BusConnects Core Bus Corridors Infrastructure Works

DLRCC Submission on 3rd round of Public Consultation

**Prepared by the Municipal Services Department, with cross-departmental input
December 2020**

Map 15 Opportunity to route cyclists away from heavy pedestrian areas – see text below

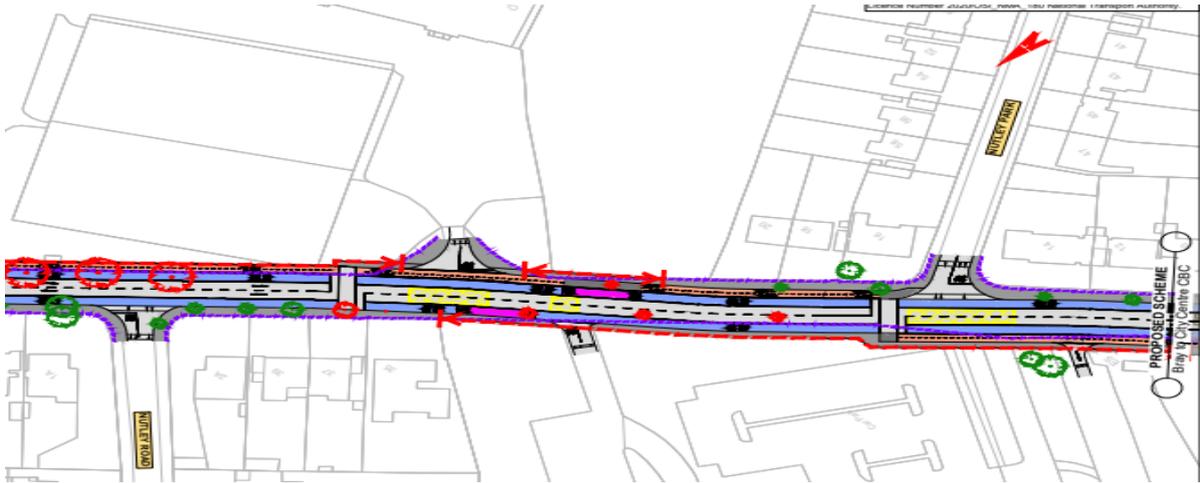
The main entrance to UCD is a very busy location with pedestrians, cyclists, buses, coaches and general traffic all interacting within a relatively confined area. Of particular concern here is the routing of all southbound cyclists directly through the area of greatest pedestrian activity - i.e. movement between the over-bridge and the bus & coach stops. A regularly observed resulting behaviour at this location is southbound cyclists entering the bus & traffic lanes to avoid the inevitable conflict and disruption which results from the high volumes of pedestrian movement in the vicinity of the cycle lane and this in turn leads to safety issues in an area of high bus, general traffic & pedestrian movements.

Given the area of land which is available adjacent to the east of the carriageway at this location, it would seem there is good potential for the southbound cycle lane to branch into two as it

approaches the southbound on ramp and thereby allow good separation of the straight through southbound cyclists by keeping them well east of the busier and often quite congested areas adjacent to the over-bridge and bus stops. Potentially the two way cycle facilities proposed as far as Belfield Park could be extended north of this location to tie in with the quiet street – Nutley Park, which in turn leads to the proposed two way cycle facilities on the south side of Nutley Lane (CBC Route 14 copied below). It is likely that this route to the east of the Belfield overpass and along Nutley Park will become a strong cycle desire line between UCD & St Vincent’s University Hospital. Adding the additional cycle lanes as suggested above would provide the missing cycle link.

DLRCC is concerned that as long as all southbound cyclists, as per the current design, are routed through such a busy pedestrian environment, pedestrian – cyclist conflict will persist at this location. Given the significant increase in cycling which DLRCC envisages over the coming years, we would urge the design team to put in place a solution which addresses this concern in a substantial way- i.e. through the provision of the suggested separate cycle lane for straight through southbound cyclists.

Map 20

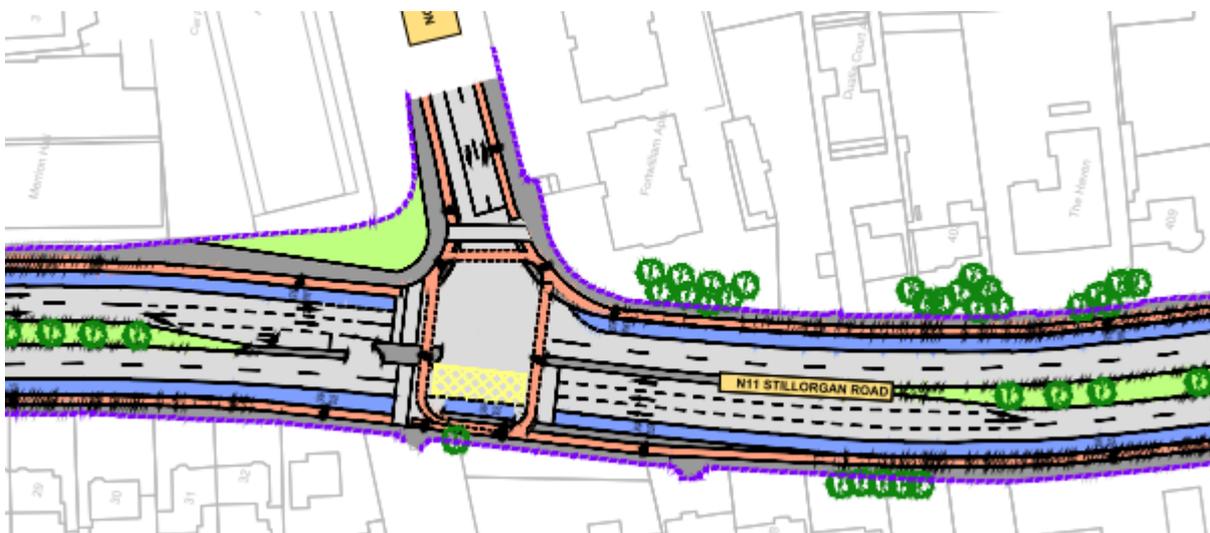
Also, with reference to the above map 20, showing the Mount Merrion Avenue junction with the N11, we request that in such instances, across both CBC routes, consideration be given to allowing straight through cycle movements on the side of the junction that presents no motorised traffic impediments provided that pedestrian movement can be safely accommodated.

Schools Access & New Junction at St Anne's Church

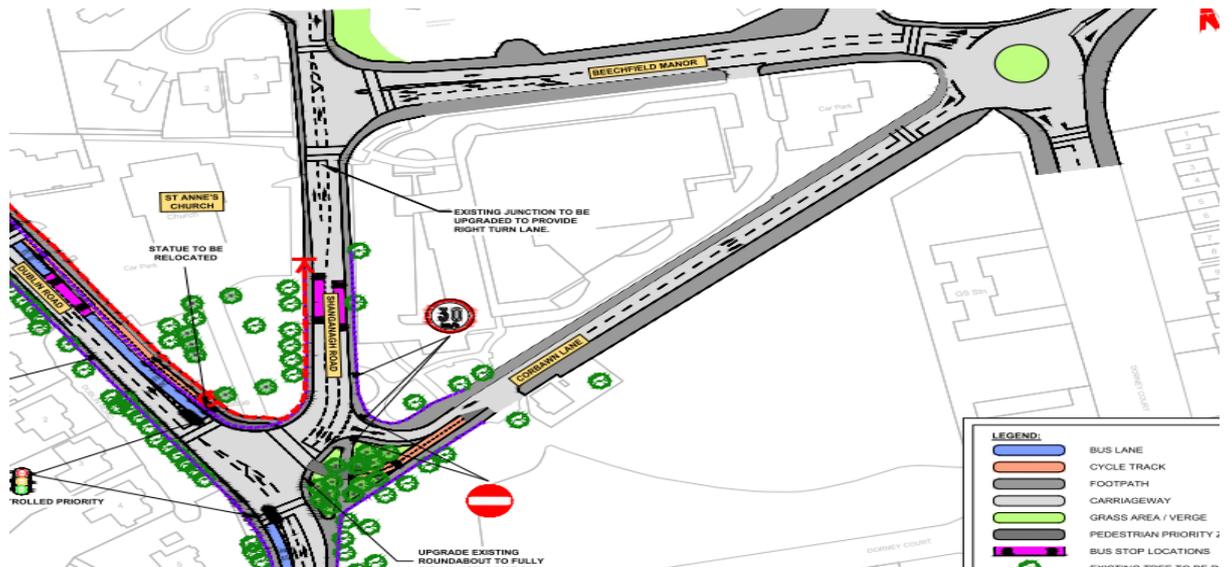
There are 3 primary schools and 1 secondary school within Shankill. The primary schools in particular are highly car dependent for access due to the inadequacy or absence of appropriate infrastructure to promote and facilitate walking & cycling. This results in traffic congestion at school drop off and collection times and adversely impacts on the movement of buses. DLRCC therefore welcomes the inclusion of new pedestrian and cycling infrastructure to provide access to the two primary schools on Stonebridge Rd. To build on these proposals, DLRCC requests that the following amendments be considered:

- Continue the two way cycle lane & footpath on the Dublin Road a little further to the north towards Rathmichael Park and cross the road at the Stonebridge Rd junction to tie in directly with the proposed cycle lane & footpath which runs along the north side of Stonebridge Rd. This would mean just one road to cross as opposed to the two proposed and would also help ensure that schoolchildren use the new facilities as opposed to continuing on the existing restricted footpath over the bridge as they presently do.

- The CBC plans propose that a section of Corbawn Lane is to become a one way street. This presents an excellent opportunity to extend the proposed two way cycle lane as far as the Corbawn Lane junction with Dorney Court from where there is good accessibility to quiet streets for cyclists. This would provide safe cycle connectivity from a substantial residential catchment direct to the schools on Stonebridge Road and would play a major role in promoting active mobility with school children. It would also improve connectivity between the anticipated strategic cycle routes – Cherrywood to Shankill to the west and the Coastal Route to the east. In addition, the extension of the cycle lane as suggested would enhance cycle connectivity to the village if the junction design at St Anne’s church was improved to provide the cycle lane from Corbawn with a signalised tie in to the traffic lane entering the village (see also comments above on improving the pedestrian and cycle environment through the village).

- The proposed signalised junction at St Anne’s church will offer significant improvements for pedestrian movement though the area. In order to similarly accommodate and promote cycle movement, we request that the design incorporates amendments to allow southbound cyclists using the new cycle lane, continue on, not just to Corbawn Lane but south to the village and on to Shanganagh Road as well. As currently configured, our concern is that the layout invites cyclists to bypass the village, when what we need to do is encourage people to access the village by bike.

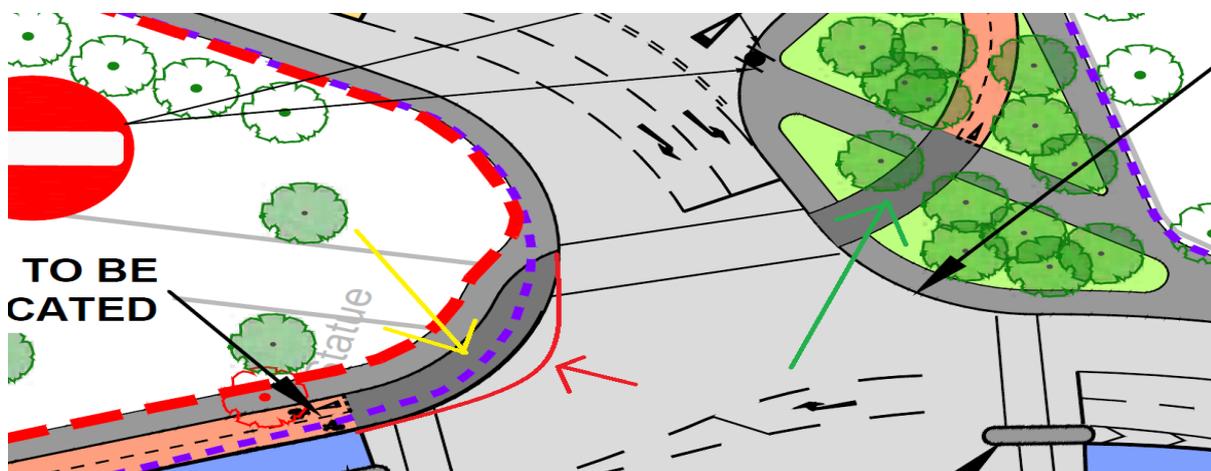
- Also at St Anne’s Church and as shown in the drawing copied below, we are concerned that the cycle lane terminates in advance of the pedestrian crossing. There would appear to be scope here to reduce the radii at this location and maintain the two way cycle track to the pedestrian crossing. At a minimum, consideration should be given to reducing the radii and allowing more space for both pedestrian and cyclist at this busy crossing location. Also, at the Corbawn Lane side of this junction, there would appear to be potential to extend the cycle lane to the crossing point with additional adjacent area allowed for pedestrians.
